MONTE VIEJO SUBDIVISION
S.E. MILITARY DR. & I.H. 37
MASTER PLAN

Re: Monte Viejo Subdivision (Amendment) **MDP# 723-C**

The City Staff Development Review Committee has reviewed Monte Viejo Master Development Plan (MDP) # 723 C (Amendment). Please find enclosed a signed copy for your files. Your plan was accepted however please note the following:

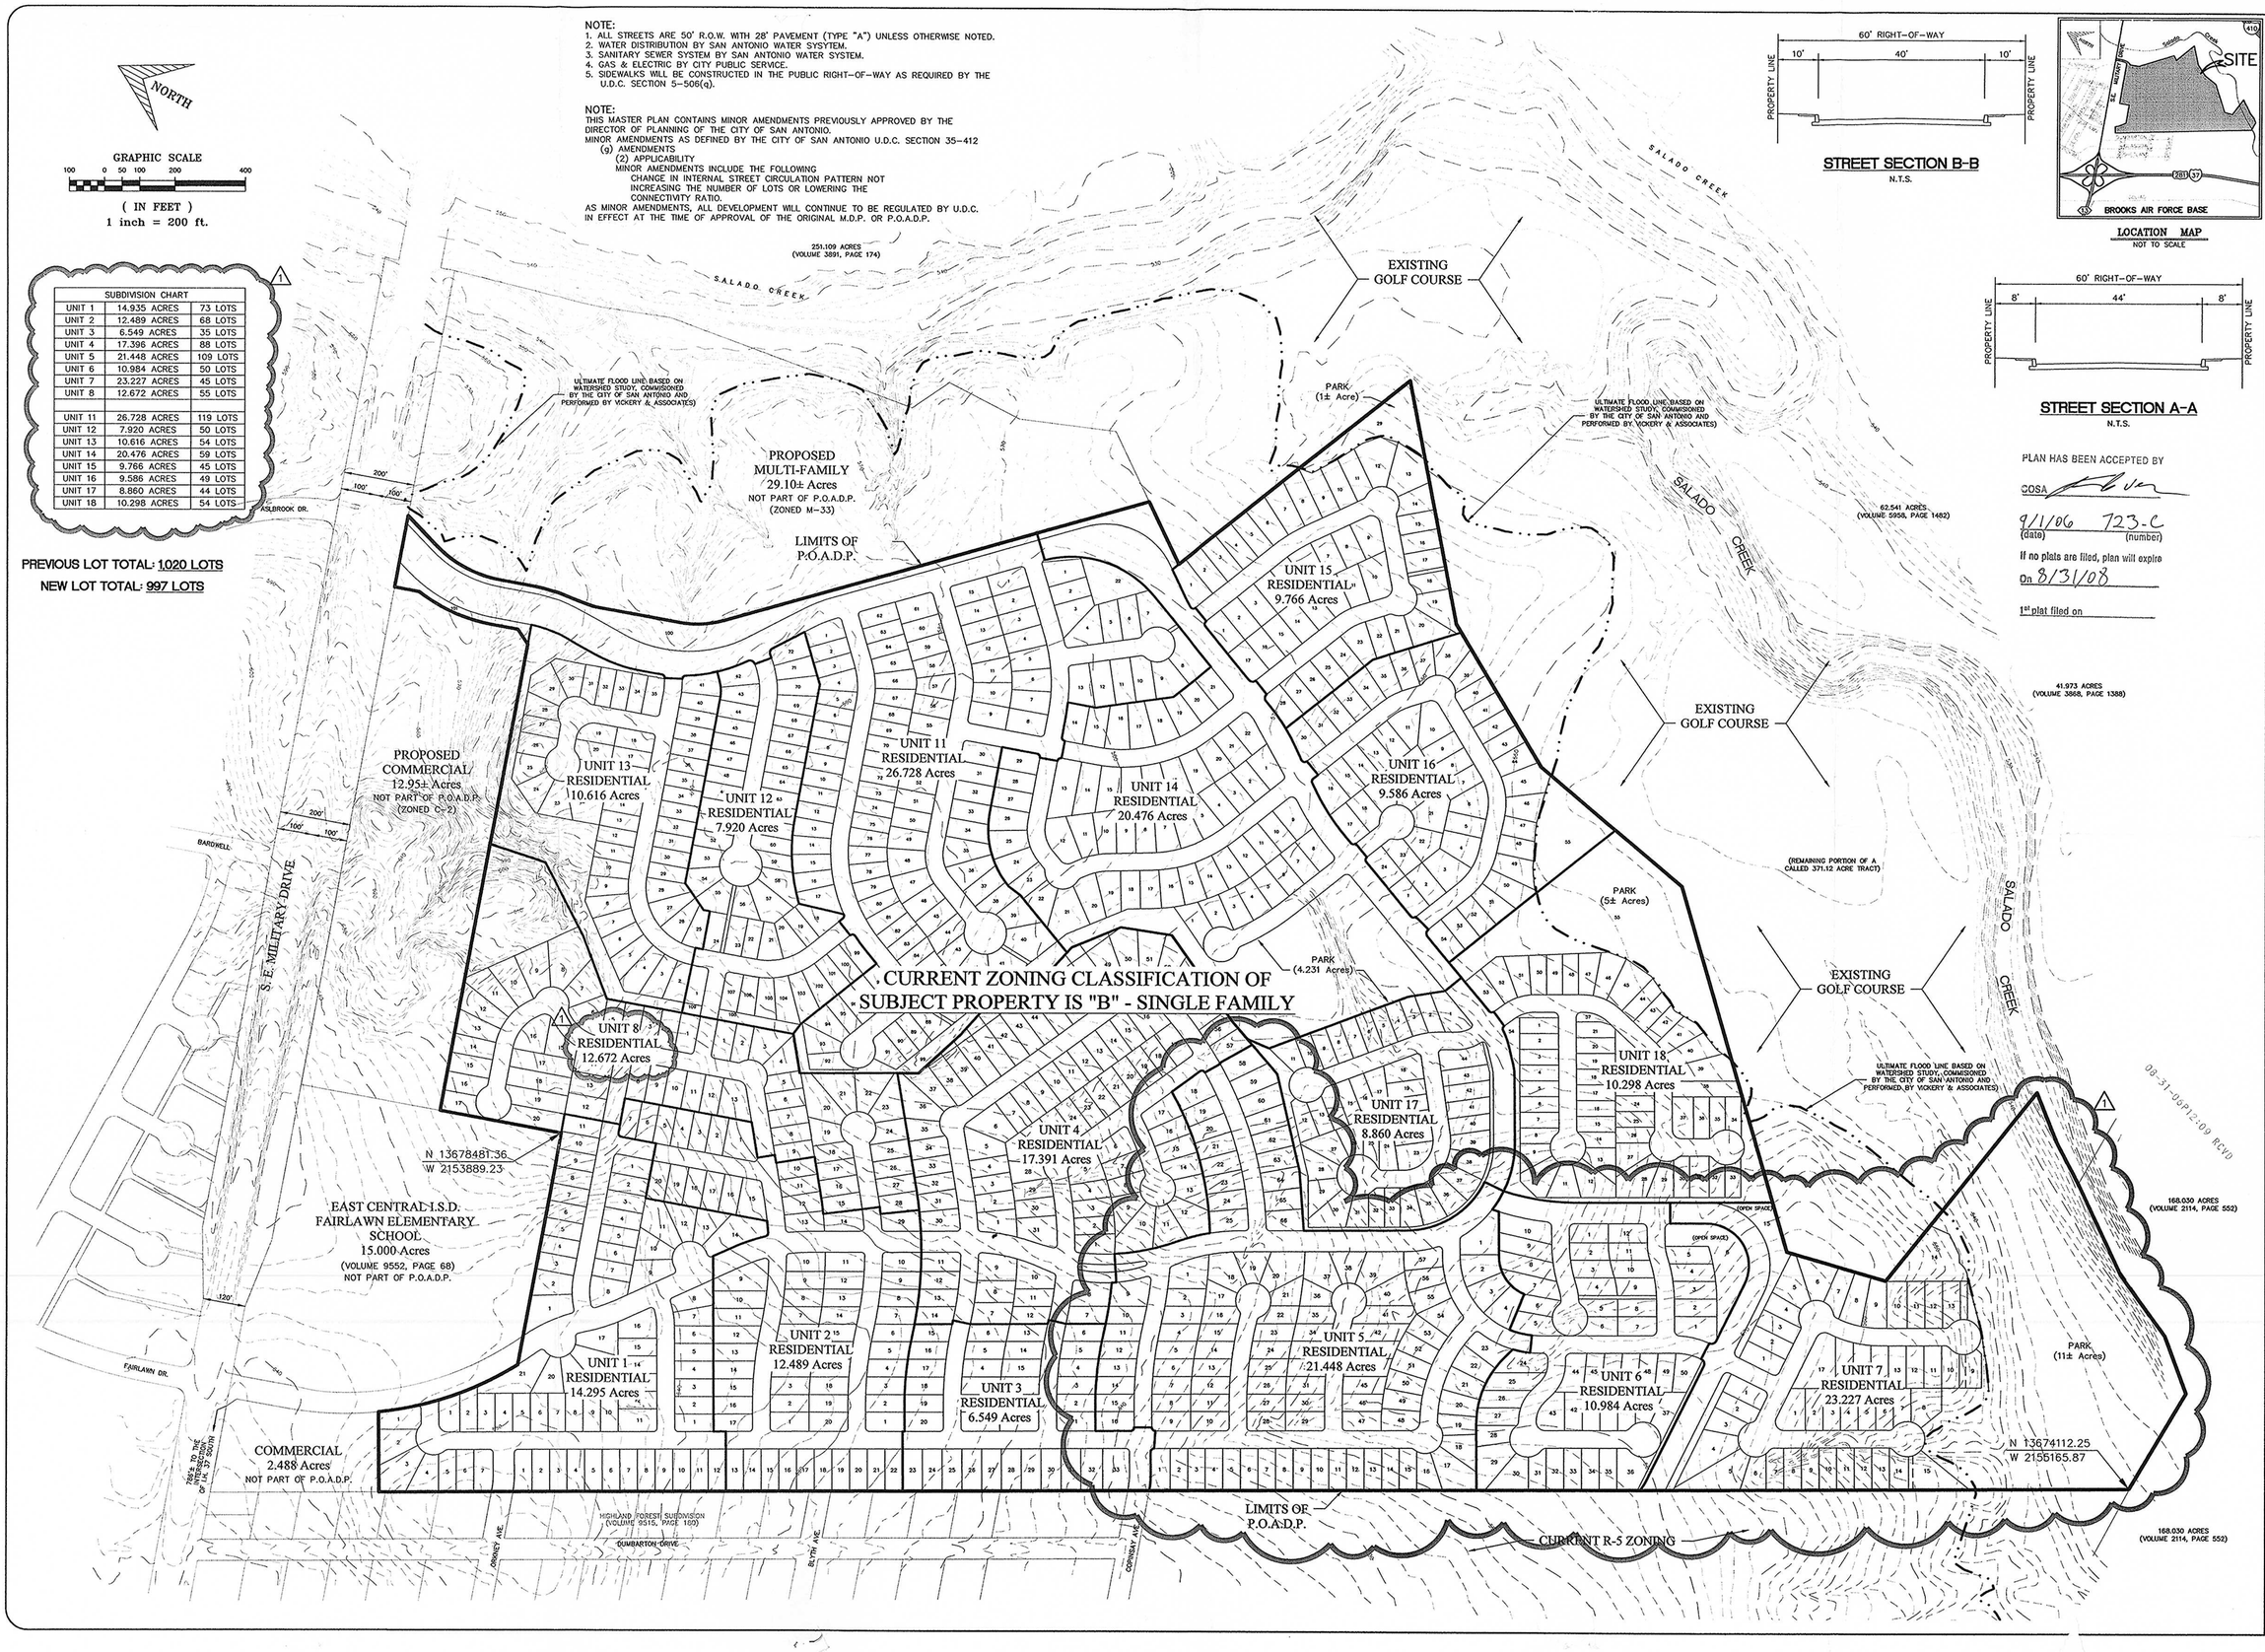
- In consideration of public safety and convenience, excessive grades by reason of topography should be avoided in street layouts and arrangements.

- Any access and R.O.W. issues along state facilities will need to be resolved with the Texas Department of Transportation (TXDOT). For information about these requirements you can contact TXDOT at 615-5814.

- This development will need to comply with tree preservation ordinance #85262. For information about these requirements you can contact Tree Preservation at 207-8265.

- It will be expected that you will plat all of the property depicted in your Master Development Plan (MDP), to include floodplains, drainage areas and open space.

1. Dedication of an approximately 2670 foot long Greenway, with a minimum average width of 50 feet. Along the length of the Greenway a trail will be constructed of crushed granite, with a minimum thickness of four inches, a minimum width of 8 feet, and sloped to drain.

2. Dedication of 2.99 acre park with approximately 50% boundary by streets. Park is to be connected to Greenway.
3. Dedication of 4.05 acres on the southern boundary of the development, across the street from the 2.99 acre park. Access from Type "B" street with a minimum width of 40 feet is required.

4. Trees shall be planted parallel to all perimeter streets at a distance of 25-40 feet on center. Trees must be a combination of Monterey Oak and Cedar Elm. Minimum caliper for all trees is two inches.

5. Installation of signage at each end of Greenway trail, and both park locations identifying such area as parks and recreation areas.
6. Developer will include in the 2.99 acre park at least three of the facilities listed in the "Basic Facilities Menu" for Neighborhood Parks in the Parks and Recreation System Plan. These facilities are to be approved by Parks and Recreation Department at time of platting.
